Technical Analysis of the “Trim Line”

John Koreny, HDR, Inc.

Outline

Incorrect Assumption that 10% Uncertainty in Calibration Targets Justifies “Trim Line”

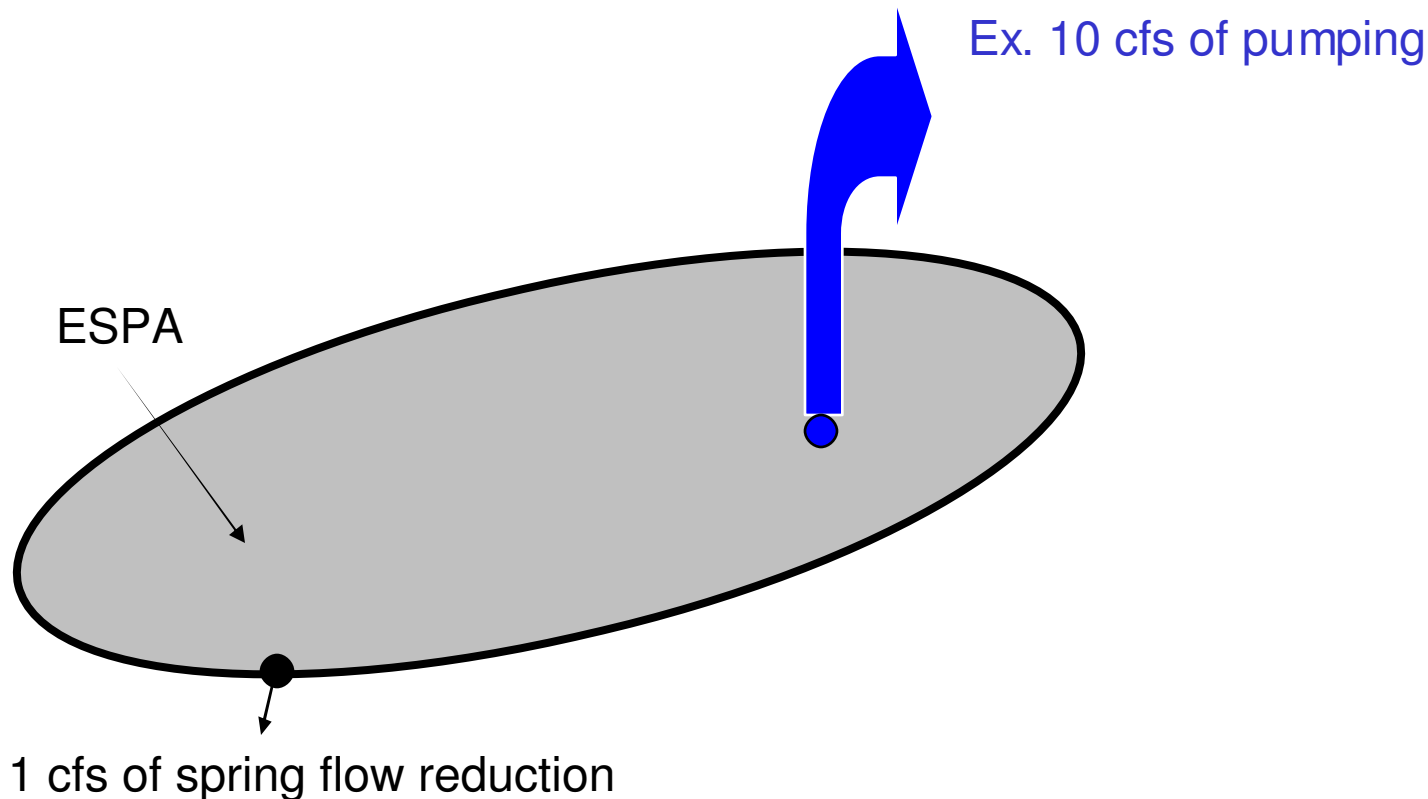
- Uncertainty in model calibration targets:
 - Ground water levels ($\pm 1-10$ ft, $<1\%$ accuracy, *hundreds of targets*)
 - Spring flow (varies, ± 2 to 5% as high as 10% depending on measuring device- weir, flow meter in canal, *targets*)
 - River reach gains (varies, ± 5 to 10 percent or greater, *targets*)
- There is no reasonable justification to assume that the model calibration target accuracy is limited to river gage accuracy or that it is 10 percent.
